Improved Technical Specifications

Quad Cities Station

Volume 3:
Section 3.3; ITS, Bases and
CTS Makrup/DOC's

3/4.1-8

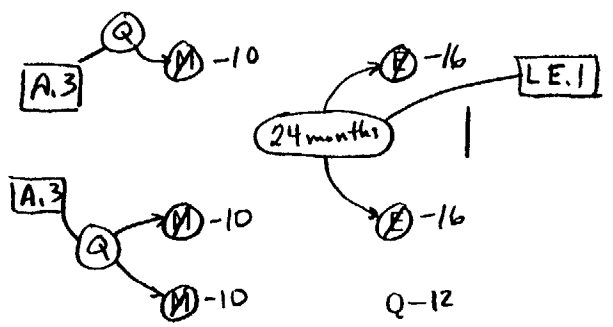
10. Deleted

add proposed SR 3.3.1.1.13

M.3

TABLE 3.2.C-1

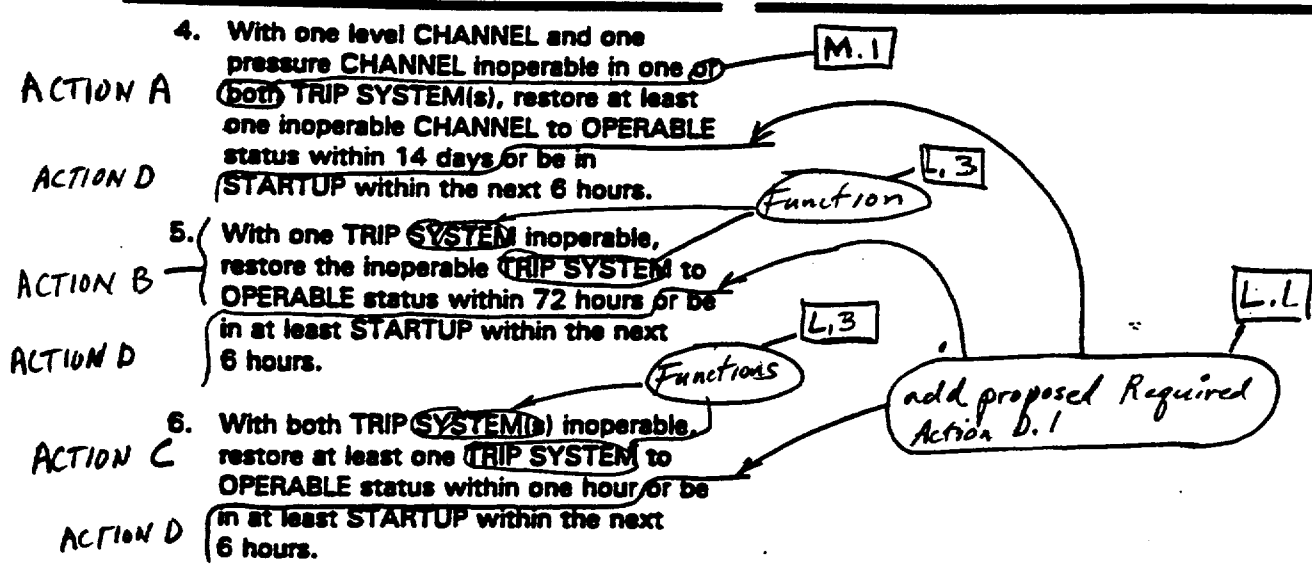
| Functional Unit |
|--|
| LC0 3.3.4.1a 1. Reactor Vessel Water Level - Low Low |
| LC0 3.3.4.1b 2. Reactor Vessel Pressure - High |

Table 3.3.5.1 Note (c)

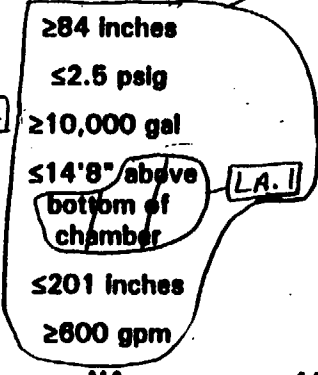
L.A.2

Table 3.3.5.1 Note (c)

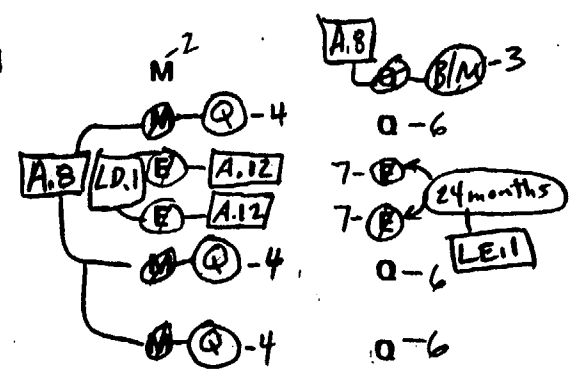
A.1
